34 Dellview Street, Tamarama – Section 96 modifications to approved townhouses (DA 317/2007).

Report dated 13 August 2010 from the Development & Building Unit.

| Section 96 Assessment Report | |
|-------------------------------------|--|
| Proposal | Section 96 for modification to relocate air conditioning units, changes to glazing, internal alterations and enclosure of terrace |

02 EAST ELEVATION
SCALE 1:50

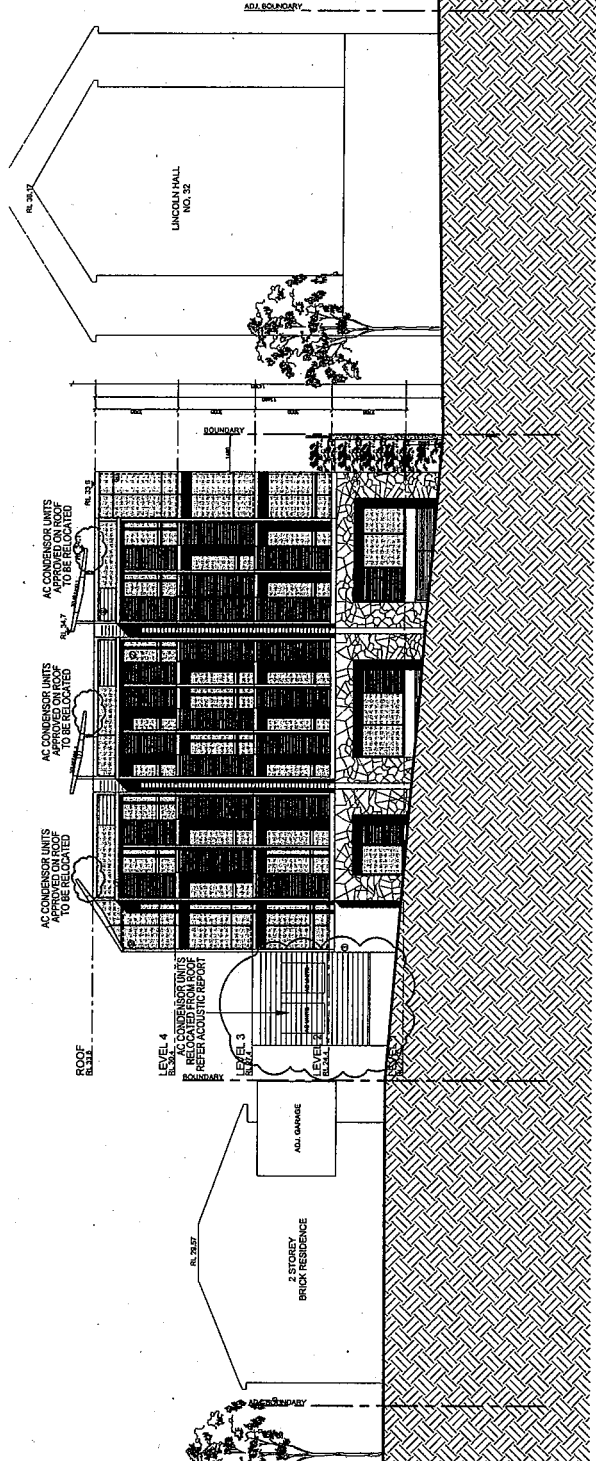
Furthermore, the proposal seeks to extend the glazing along the entire rear of the building and also to modify the glazing to include sliding glass doors along the rear which incorporate a 1m high fixed glass balustrade (refer to section drawing for detail). In this case, the balustrade would abut the sliding doors where the distance between balustrade/sliding doors and approved rear louver screening would remain non trafficable (distance of approximately 1m). The intention being to provide sliding doors that open for breeze/ventilation, but do not allow someone to step out beyond the location of the doors (i.e. one would remain indoors at all times).

However, it is important to note the inconsistent plan details as outlined in previous instances (by both Council and Court) where balconies were deleted on levels 2 and 3 due to concerns about privacy. As such, the applicant amended the plans so that on level 2, this area is labelled as 'non trafficable tiles', though on level 3 there is no reference to being non-trafficable. To clarify this element further, the applicant has submitted a section drawing of this element to clarify matters and specify the location of sliding doors, balustrade and louver screen, details previously not provided to Council or the Court.

Importantly, the approved development includes glazing along the rear of the building with deleted balconies from level 2 and 3. The proposed modification now before Council is not to reinstall balconies but rather to provide an opening at the rear of the building (note the louver screen remain setback from this point by 1m) which are sliding doors (rather than window) with glass fixed balustrade abutting the sliding doors, whereby a person standing at the balustrade remains wholly within the building at all times. In this instance, the resultant effect is comparable to the approved scheme which allows one to stand at the window with outlook to ocean, is now a sliding door they cannot step out from, and therefore the same outlook/view.

Furthermore, as the louver screens remain as per approved, the privacy impact/overlooking from sliding doors is akin to the approved development of windows here, specifically as one would stand in the same position with each, and not any further.

Additionally, it is noted that the original approved plans for the development, at the deletion of balconies on level 2 and 3 sought fixed glazing to a height of 1m (to rear of building), therefore this element has in essence been previously approved by the Court. It is also noted that at the time, condition 2(e) was imposed which seeks the 1m high panels to be non transparent panels (i.e. translucent) to reduce privacy impacts, which is recommended to remain on any consent granted.

As such, the proposed modifications are considered to be in accordance with the originally approved intent of the building. The additional glazing to extend the entire length of the rear is considered to have a similar impact to the remaining glazed area of the rear elevation, the extension being minor (less than 1m lengths).

- (e) The 1metre high fixed glazing panels to the rear shall be translucent to minimise privacy impacts.
- (f) The former balconies to the rear (eastern elevation) of level 2 and 3 (shown on plan to be the area between the 1m high fixed balustrade and the screen louvers) shall be non-trafficable. In this regard no balcony like structure, such as a tiled concrete slab, is to be provided off the level 3 living areas – this area is to be void.

02 SOUTH ELEVATION
SCALE 1:50

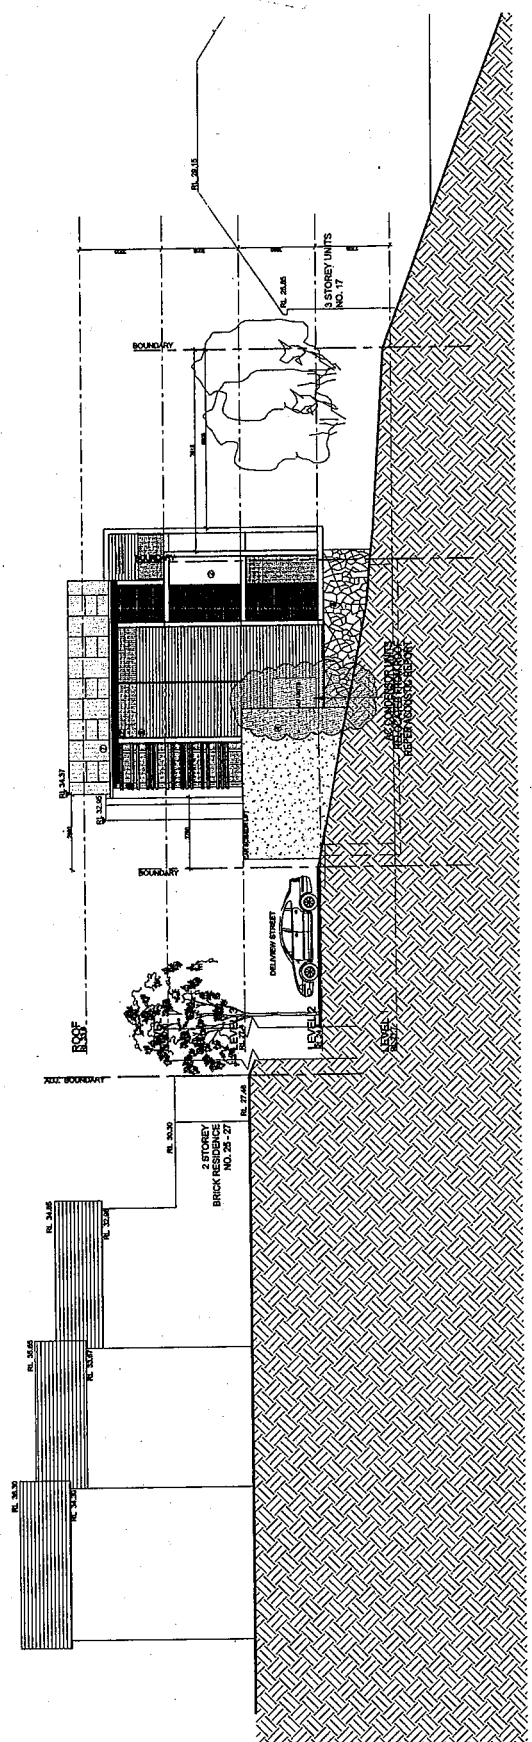
'The removal of the air conditioning units from the roof is acceptable, however, there is an inconsistency between the description in the summary and the plans. The summary states that the units are to be relocated to ground level (level 1), however, one unit is relocated to Level 1 and the other two units are relocated to the garage and shown on the plans and elevations on level 2.

While I accept the recommendations of the noise report that, if properly enclosed, the noise impacts will be acceptable, it is preferable if these units are located on level 1 as described. This would ensure that the units are below the garage and fence level of the adjoining property and limit their potential visibility from this property'.

As the Court accepted the recommendations of the acoustic report and the relocation of the air conditioning units from the roof to lower levels, it is considered this matter of the proposal is acceptable in this instance. The plans submitted in the current application seek a single unit on level 1 on the northern side of the building, and two units to the southern side of the building, attached to the rear of the garage at level 2, to enable landscaping to occur below.

In order to satisfy the recommendations of the Court, whilst still allowing landscaping to occur, it is recommended conditions be imposed that clearly clarify the relocation of this units, to ensure the discrepancies raised by the Court are overcome. As such, the northern A/C location is acceptable, and the two A/C units to the south, shall be conditioned to remain attached to the garage though at level 1, thereby below the garage and fence level of the adjoining property, whilst still providing scope for some landscaping below.

- (a) The two air conditioning units to the southern side of the building shall be attached to the rear of the garage, however at level 1 (rather than level 2). As such, these units shall be located below the garage and fence level of the adjoining property to the south.
